Re: Proposal for Temporary Leachate Collection Wells

12th Street Landfill Operable Unit No. 4

Allied Paper, Inc./Portage Creek/Kalamazoo River Superfund Site

56393-00 BERK020 FIGURE 1

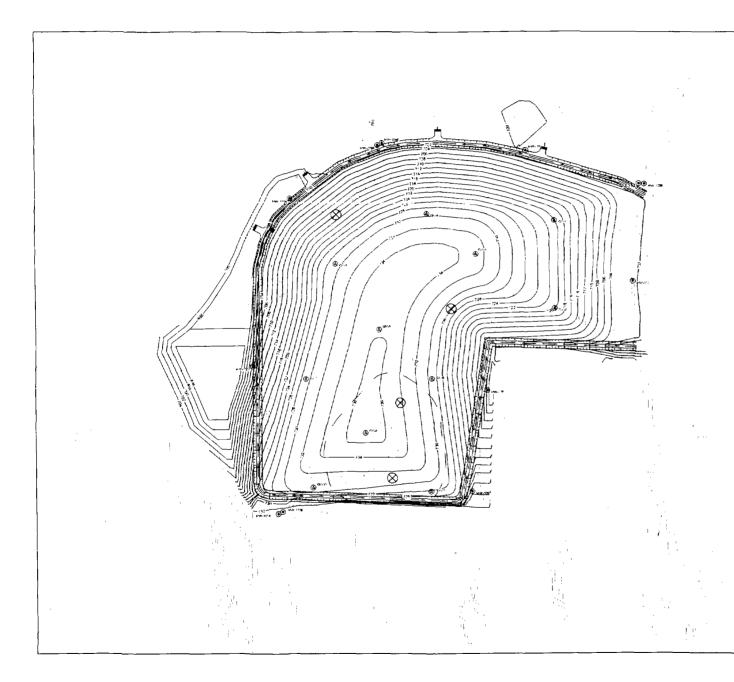
In lieu of digging test pits, CRA is proposing to install up to four temporary leachate collection wells in the approximate locations presented on the attached figure. Two temporary leachate collection wells will be installed within the delineated area described as the "Approximate Location of Construction Debris (Geraghty and Miller, 1994a)". A third leachate collection well will be installed directly north of the delineated construction debris area, at the approximate bend in the landfill sideslope as it proceeds around the northwest corner of the adjacent Michigan Department of Natural Resources and Environment (MDNRE) property. During ongoing landfill excavation and regrading activities in this area, construction debris has been encountered and a leachate seep has been observed. The proposed well would be installed near the top of the existing slope in order to intercept the leachate before it potentially leaves the Site. It should be noted that the quantity of

In addition to the three potential leachate collection wells within the identified locations of construction debris, one other temporary leachate collection well will be installed along the northwest side of the 12th Street Landfill. At present, there is a leachate seep emanating from the northwest sideslope approximately midway between former monitoring wells MW-2 and MW-3. A temporary leachate collection well will be installed above the observed seep area, near the top of the current landfill sideslope. Slope excavation activities have been completed around to the west side of the landfill, adjacent to the asphalt plant property, and no construction debris was observed nor have any additional seeps been identified in this area.

The proposed temporary leachate collection wells will be drilled using appropriately sized hollow stem augers such that 4-inch diameter wells screens and casing may be installed. The intended depth will be approximately 20 feet within the construction debris area, or until the interface between high permeability construction debris and low permeability paper residuals or clay is observed. It is expected that the presence of construction debris may prevent drilling to the bottom of the previously placed construction debris (i.e., may hit refusal). If more than two attempts are required at any particular location, then the well will be placed above the depth of refusal, assuming perched water has been encountered. The other two temporary leachate collection wells to the north and northwest may be shallower in depth, but will also be installed to the observed interface. If no construction debris or perched water is encountered, then a temporary leachate collection well will not be installed at that particular location.
